Advanced Response to

Request for Additional Information 554 (6572), Question 11.02-27

U. S. EPR Standard Design Certification

Review Section: 11.02 - Liquid Waste Management System

Figure 10.4.8-2—Steam Generator Blowdown Demineralizing System Flow Diagram Sheet 1 of 4

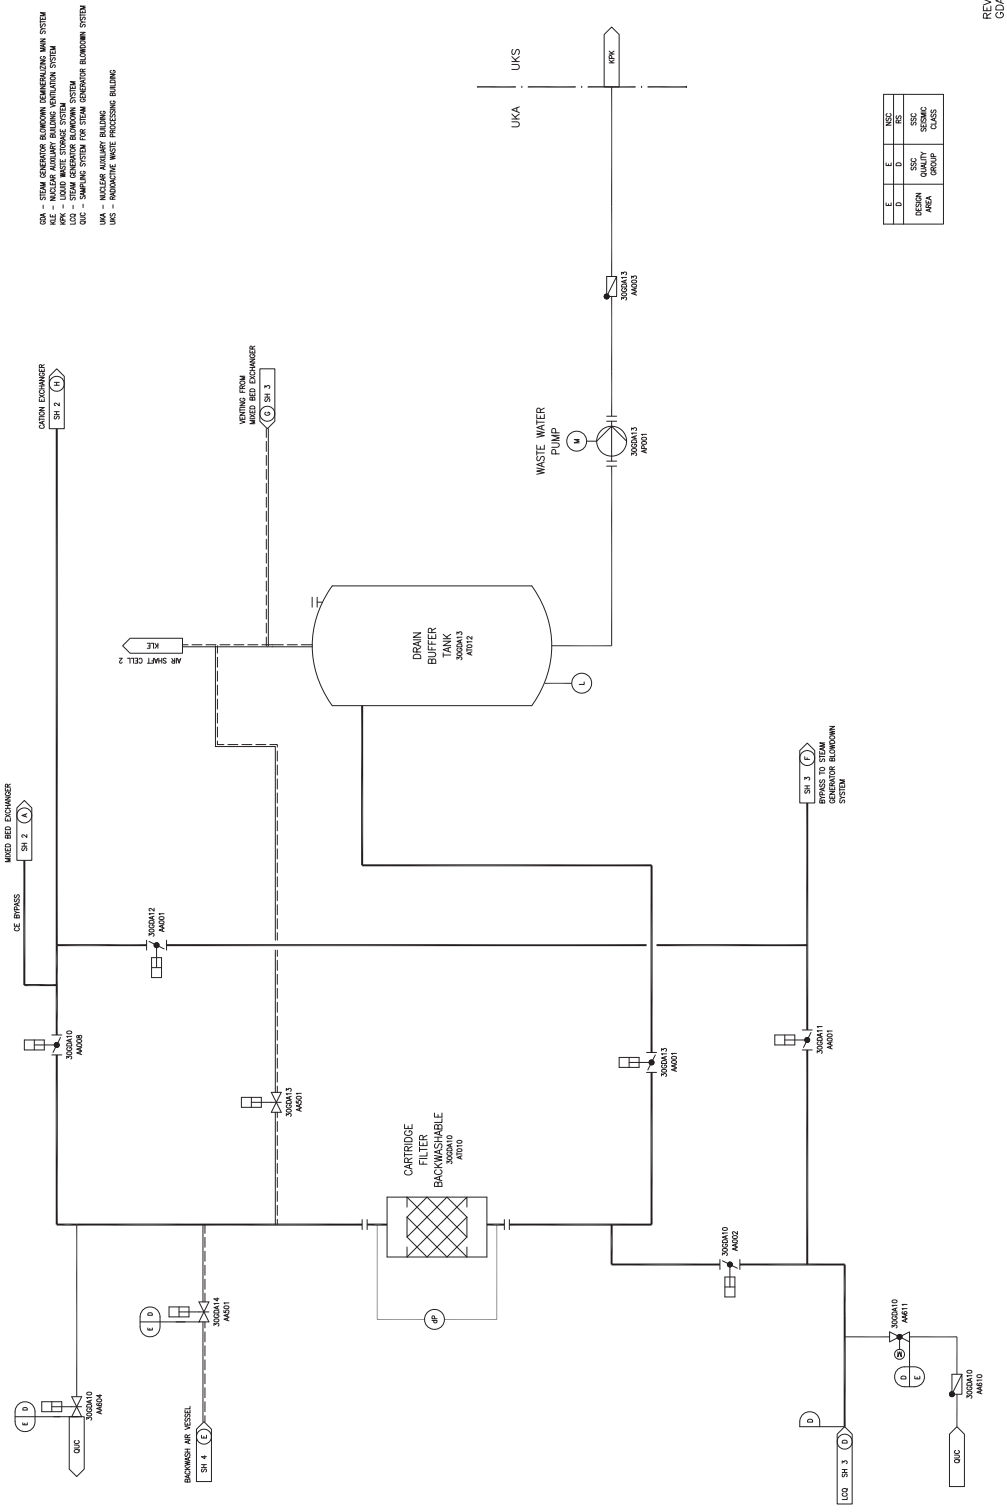
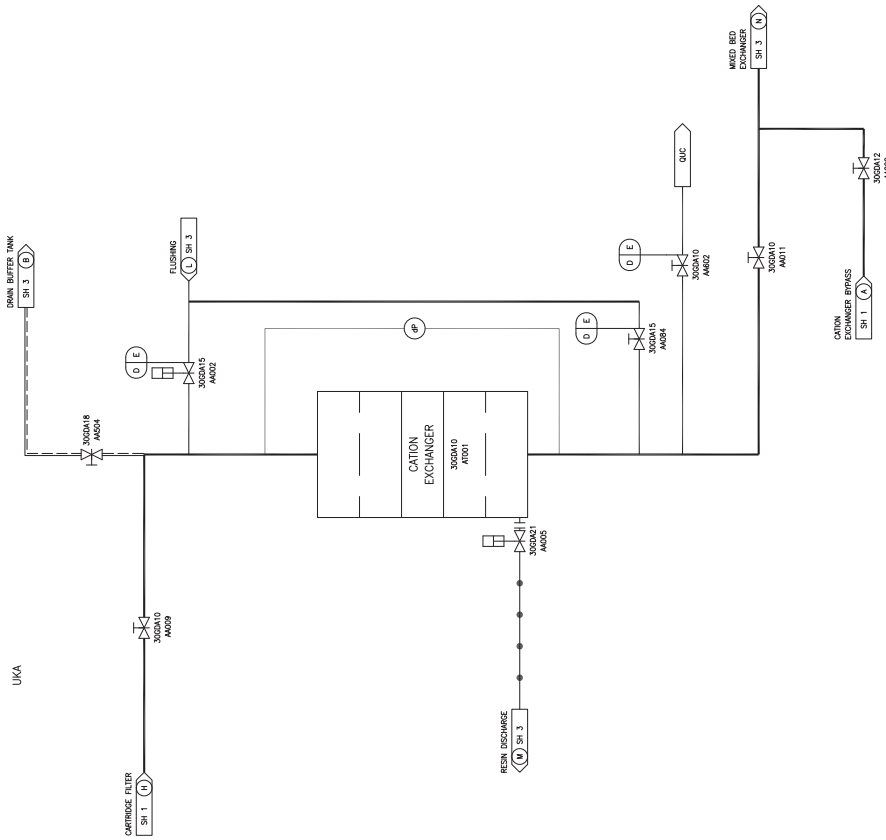
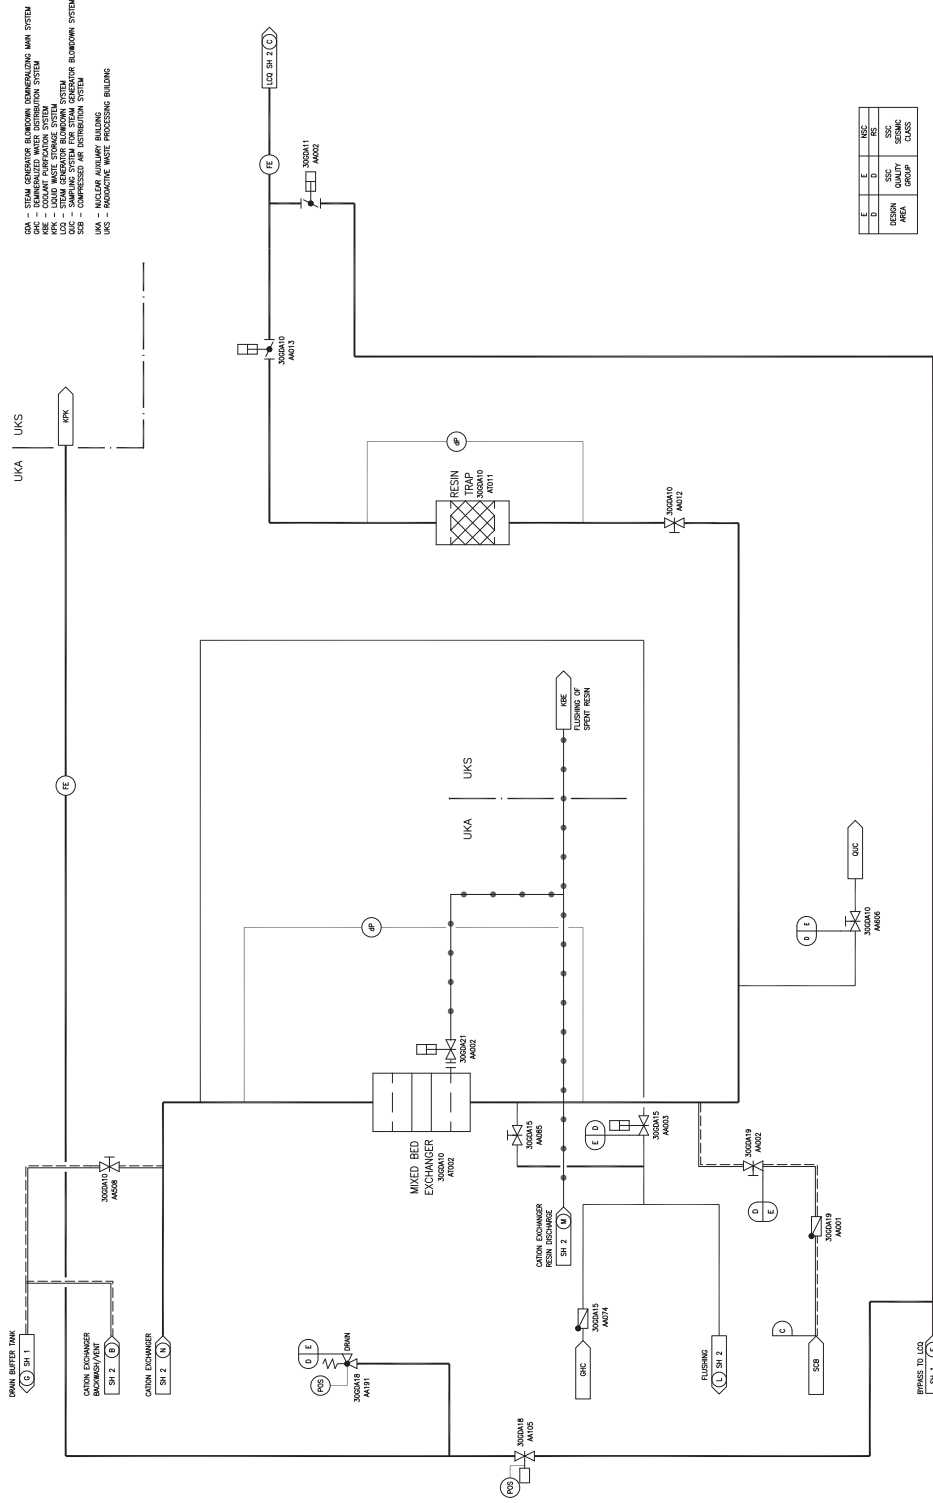
U.S. EPR FSAR Tier 2, Figure 10.4.8-2 Sheets 1, 2 and 3, shall be updated as shown in the attached mark-up to reflect the changes to the seismic classification.

U.S. EPR FSAR Tier 2, Figure 10.4.8-2, will be revised as described in the response and indicated in the enclosed markup.

All indicated changes are in response to RAI #554, Question 11.02-27

Figure 11.2-1—Liquid Waste Storage System

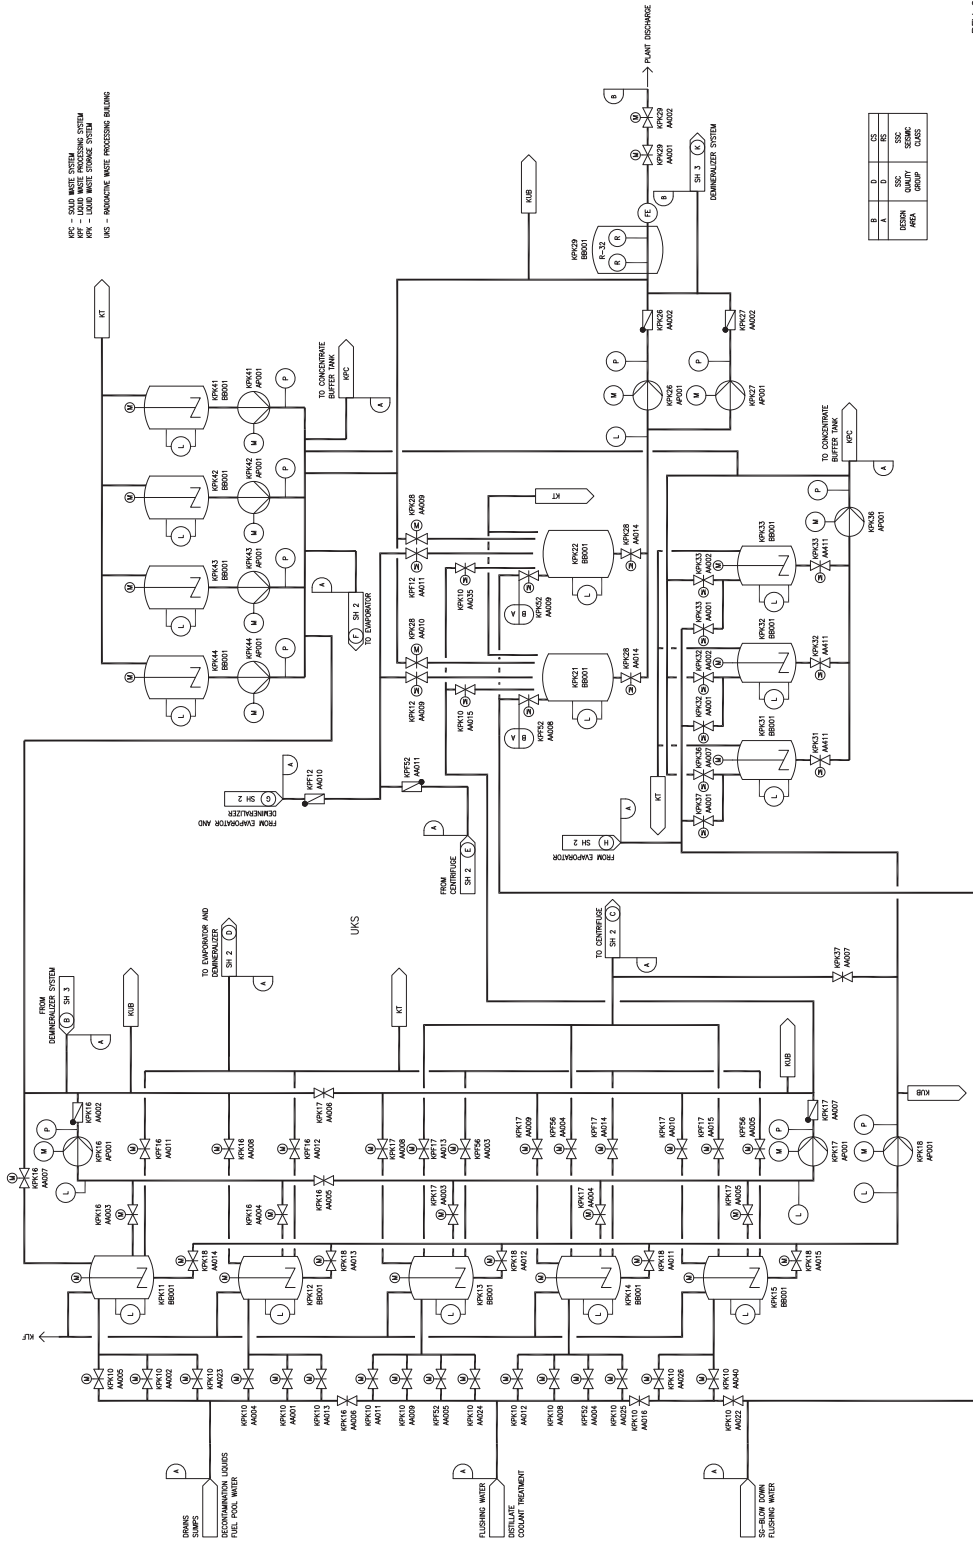
U.S. EPR FSAR Tier 2, Figure 11.2-1, will be updated to reflect the changes to the seismic classification.

U.S. EPR FSAR Tier 2, Figure 11.2-1, will be revised as described in the response and indicated in the enclosed markup.
